R20TS0494EJ0100

RX Family SCI Module Firmware Integration Technology, RX Driver Package

Outline

➤ CPU processing that results in correct transmit data

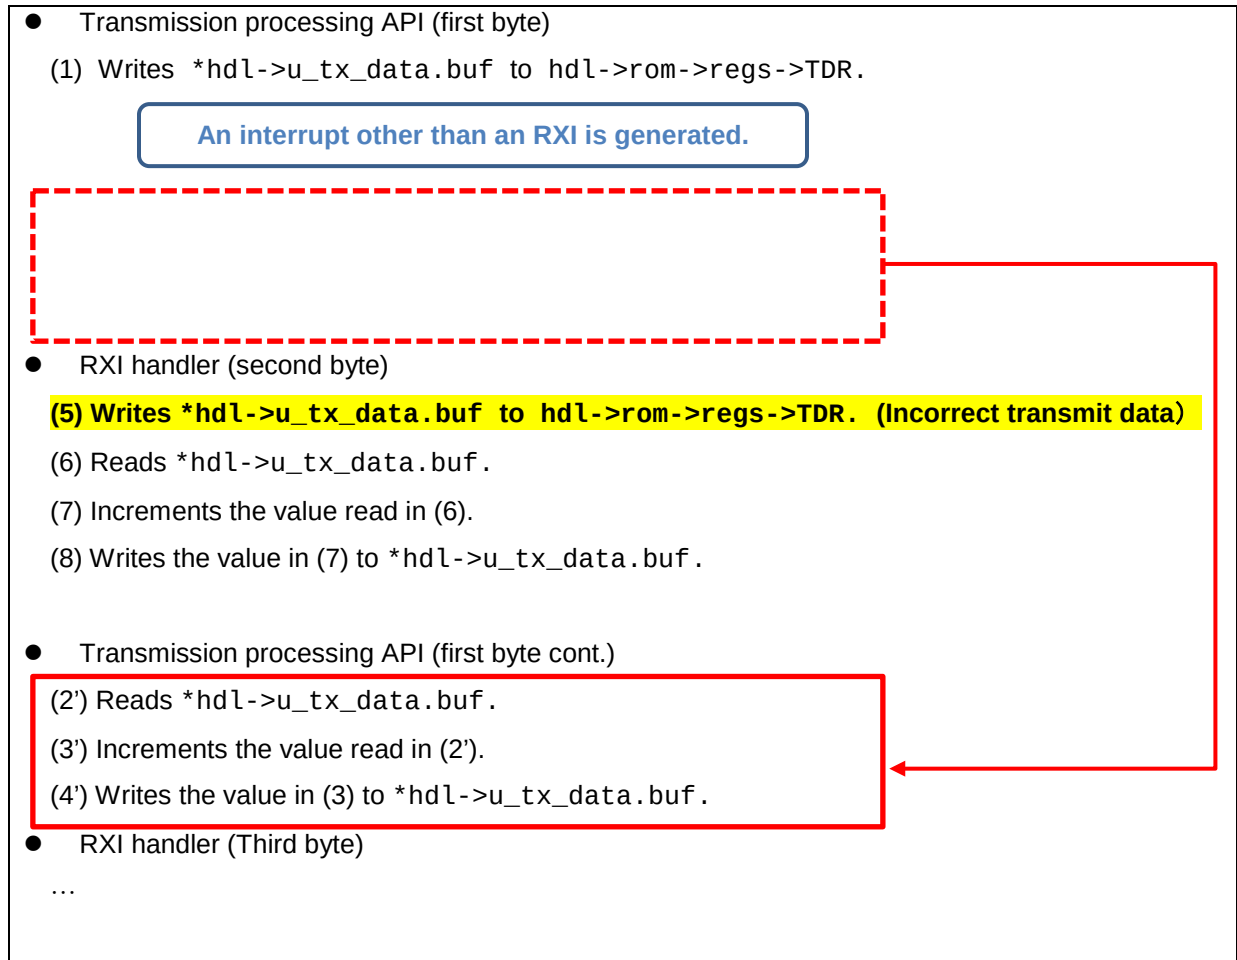
The processes enclosed in a red frame show the steps involved in incrementation of the transmit data buffer counter.

After data is written to the TDR, both processes are performed before the next data is sent (RXI handler).

- Transmission processing API (first byte)
 - (1) Writes *hdl->u_tx_data.buf to hdl->rom->regs->TDR.
 - (2) Reads *hdl->u_tx_data.buf.
 - (3) Increments the value read in (2).
 - (4) Writes the value in (3) to *hdl->u_tx_data.buf.
- RXI handler (second byte)
 - (5) Writes *hdl->u_tx_data.buf to hdl->rom->regs->TDR.
 - (6) Reads *hdl->u_tx_data.buf.
 - (7) Increments the value read in (6).
 - (8) Writes the value in (7) to *hdl->u_tx_data.buf.
- RXI handler (third byte)

When an interrupt other than an RXI is generated between (1) and (2) in "CPU processing that results in correct transmit data"

If transmission processing (1) is completed while processing an interrupt other than an RXI, RXI handler processing (second byte) is performed without incrementing the transmit buffer counter in (2) to (4).

For this reason, a wrong value is written to the TDR, resulting in incorrect transmit data.

You can avoid this problem by one of the following methods. Correction is shown in red.

- (1) Disable interrupts before the “SCI_TDR” processing.

```
R_BSP_InterruptsDisable(); /* Disable interrupts */
SCI_TDR(*hdl->u_tx_data.buf++);
R_BSP_InterruptsEable(); /* Enable interrupts */
```

- (2) Increment “*hdl->u_tx_data.buf” before the “SCI_TDR” processing.

Replace the line in “Before correction” with the following four lines in red.

```
uint8_t *buf_copy;
buf_copy = *hdl->u_tx_data.buf;
*hdl->u_tx_data.buf++;
SCI_TDR(buf_copy);
```
